# UNITED STATES PATENT AND TRADEMARK OFFICE

APPLICATION NO.	FILING DATE	FIRST NAMED INVENTOR	ATTORNEY DOCKET NO.	CONFIRMATION NO.
09/868,364	10/12/2001	Franz Schellhorn	P01,0212	8559
26574	7590	06/03/2005	EXAMINER	
SCHIFF HARDIN, LLP PATENT DEPARTMENT 6600 SEARS TOWER CHICAGO, IL 60606-6473			RUDE, TIMOTHY L	
			ART UNIT	PAPER NUMBER
			2883

**Office Action Summary**

## DETAILED ACTION

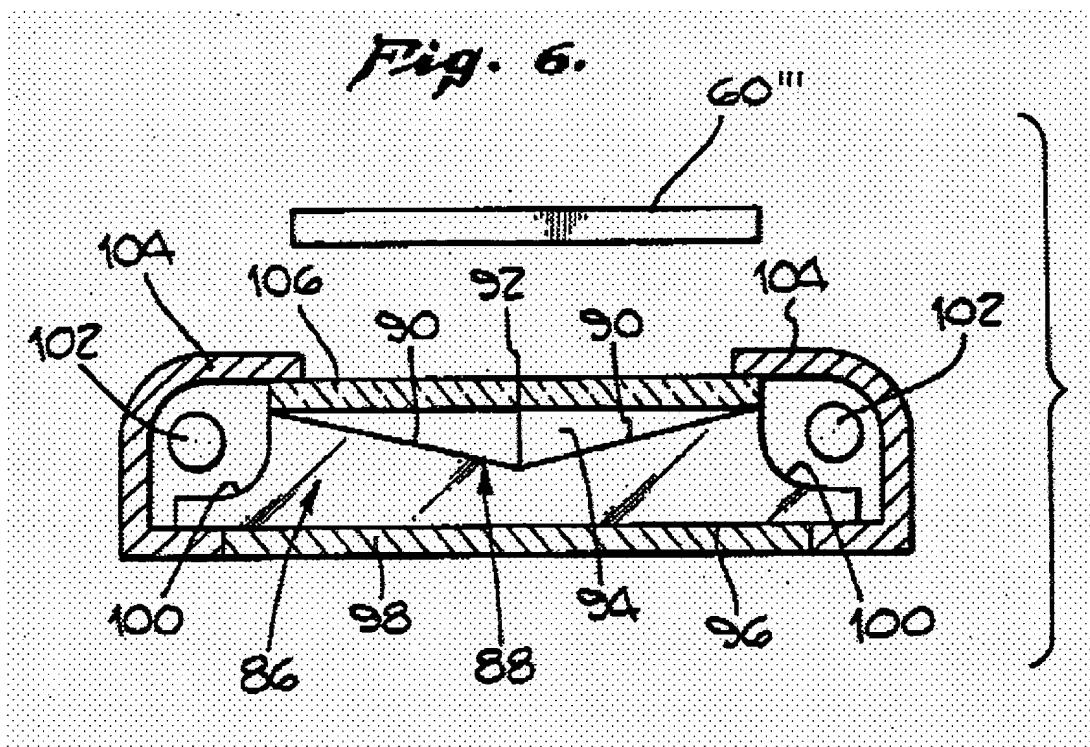
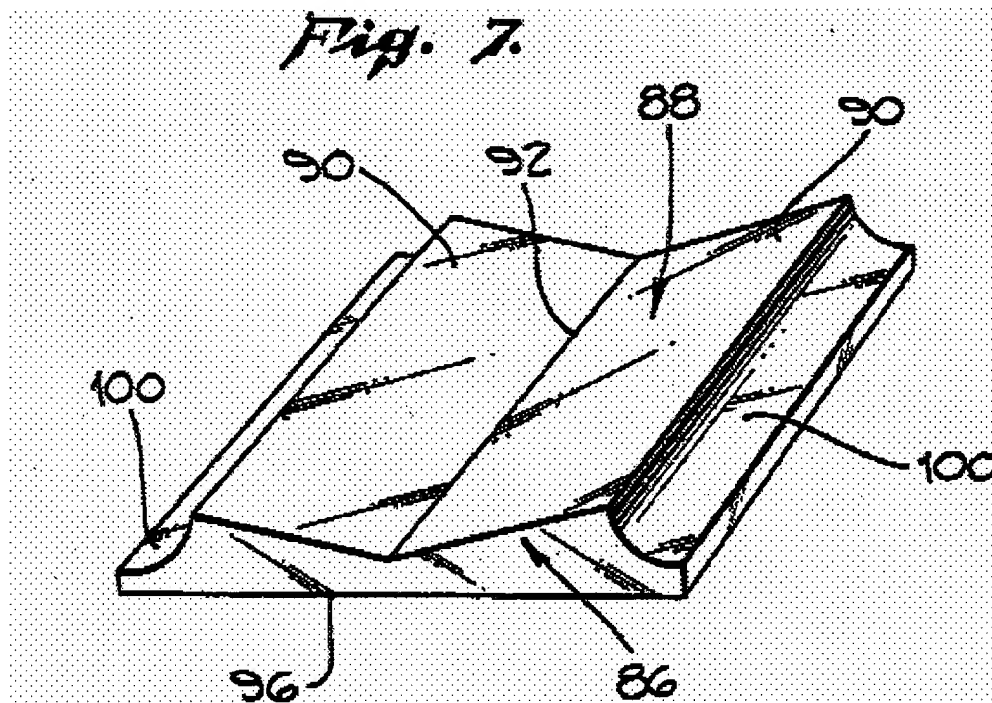
2. Claims 26, 43, 27, 29, 31, and 38 are rejected under 35 U.S.C. 102(b) as being anticipated by Kalmanash USPAT 5,211,463.

As to claim 26, Kalmanash discloses [entire patent, especially Figures 6 and 7] a light source element, comprising: a light waveguide, 86; a light exit face, 88, and at

least one light entry face, 100, on the light waveguide; a surface, 96, lying opposite the light exit face, and at least some of lateral surfaces [surface facing viewer in Figure 7 and surface behind (away from viewer), as well as the lower vertical portions of the left and right surfaces] connecting the light exit face and the opposite surface being covered with reflectors, 104 on left and right, that at least one of reflect and diffusely return light; and the light entry face [concave surfaces, 100] being formed by a part of at least one of the lateral surfaces and the opposite surface not provided with a reflector and being arranged at an acute angle [concave curve has a portion that is at an acute angle – please note Applicant has not claimed planar (flat) surfaces] relative to one of principal directions of extent of the light waveguide.

As to claim 43, Kalmanash discloses [entire patent, especially Figures 6 and 7] a liquid crystal display [title] with a light source element, comprising:

- a liquid crystal element, 60", arranged at a side of a light exit face, 88, of the light source element;
- the light source element comprising a light waveguide, 86, having said light exit face and at least one light entry face, 100;
- a surface, 96, lying opposite the light exit face and at least some of lateral surfaces [surface facing viewer in Figure 7 and surface behind (away from viewer), as well as the lower vertical portions of the left and right surfaces] connecting the light exit face and

the opposite surface being covered with reflectors, 104 on left and right, that at least one of reflect and diffusely return light; and

the light entry face, 100, being formed by a part of at least one of the lateral surfaces and the opposite surface not provided with a reflector and being arranged at an acute angle [concave curve has a portion that is at an acute angle – please note Applicant has not claimed planar (flat) surfaces] relative to one of principal directions of extent of the light waveguide.

As to claim 31, Kalmanash discloses the light source element according to claim 26 wherein the reflectors are integrally connected to one another [as assembled and as integrated by lower reflector, 98, per Figure 6].

As to claim 38, Kalmanash discloses the light source element according to claim 26 wherein the light waveguide comprises a projection extending beyond a lateral surface and aligns with the light exit surface, at least one light source being arranged under said projection [top is considered down in Figure 6, please note Applicant has not claimed which way is up].

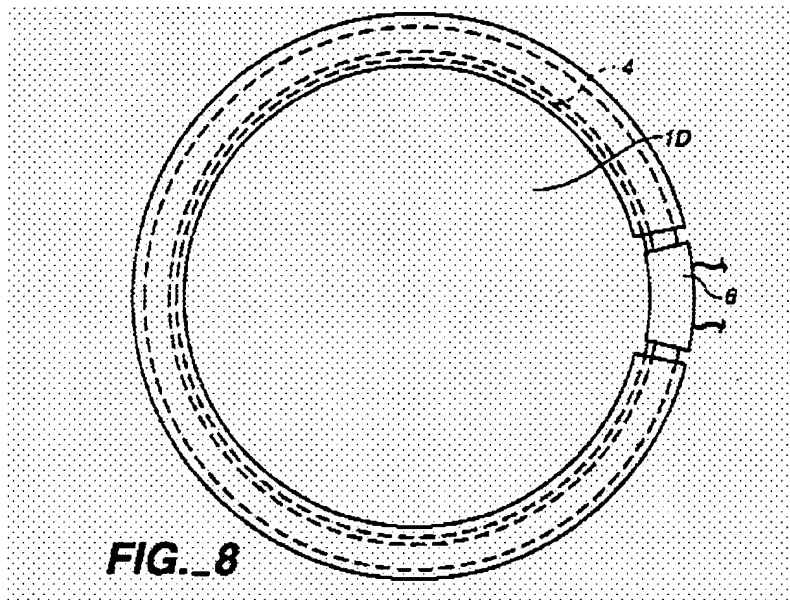
Akahane teaches that his light source element can be any of a number of shapes to accommodate different displays including a closed ring per Figure 8.

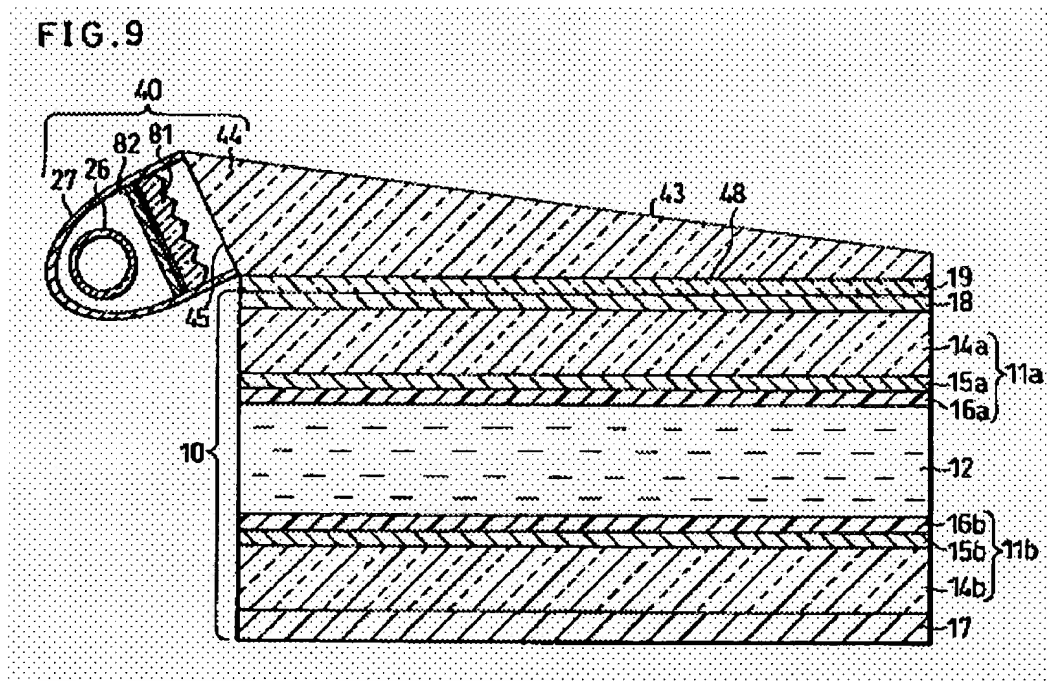
Sawayama teaches the use of a triangular projection for the illuminator in Figure 9 to achieve desired direction of the travel of light to illuminate a display [abstract].

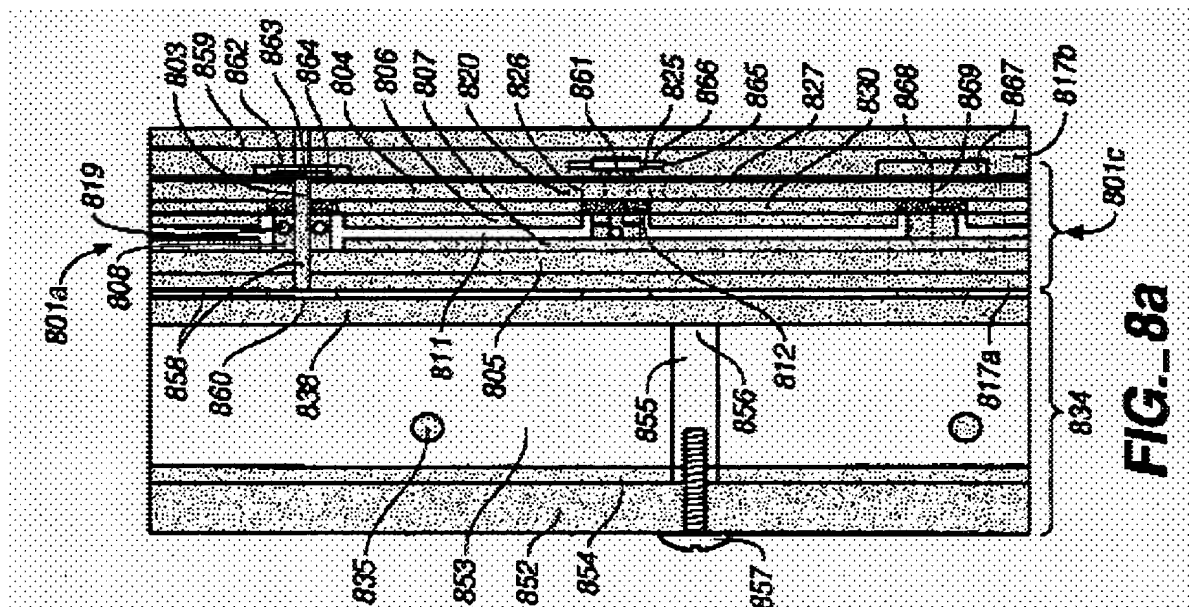
Ge teaches a display wherein the liquid crystal element is held spaced from the light exit face by spacers to provide good strength and support for a diffuser [col. 8, line 63 through col. 9, line 22].
